Product Change Notification

Date Issued :	May 15, 2023	PCN Number :	513663
Reason for Change :	Packaging Method/Quantity Changing		
Description of Change :	This notification is to inform you about part(s) listed in this notice that will undergo changes for new Delivery unit. No changes will be made to the product as a result of this change.		
Reason for Short Notice :	Corrective Actions		
Assessment of Change :	No change to parts - Form/Fit/Function		
Planned Implementation Date :	June 14, 2023		
Sample Availability Date:	June 13, 2023		
Internal Molex Qualification Date :	May 24, 2023		
Last date to request Samples by Customer :	June 13, 2023

New Packaging

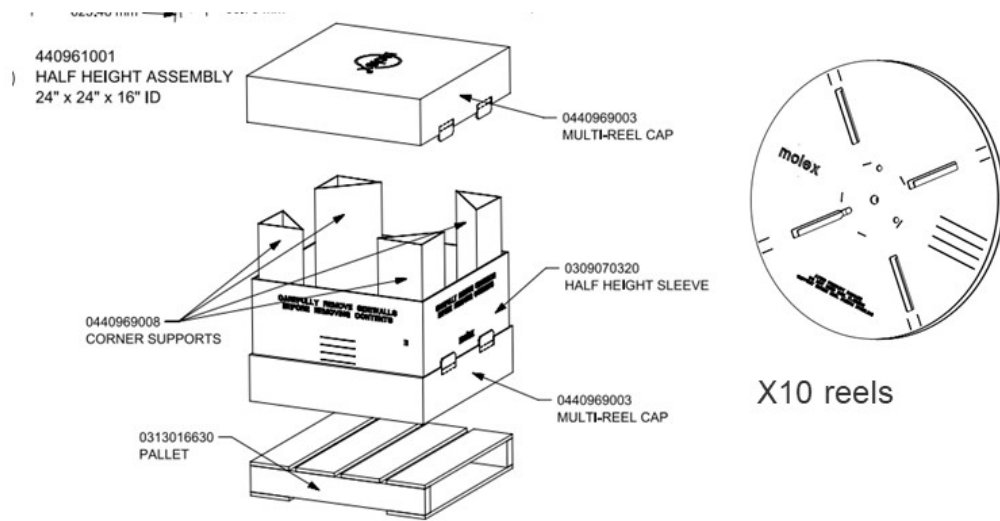
PCN will provide a more robust packaging type to a cylinder and be moved on a pallet. The Delivery Unit quantity will increase to 200,000 pcs, as 10 reels fit this container.
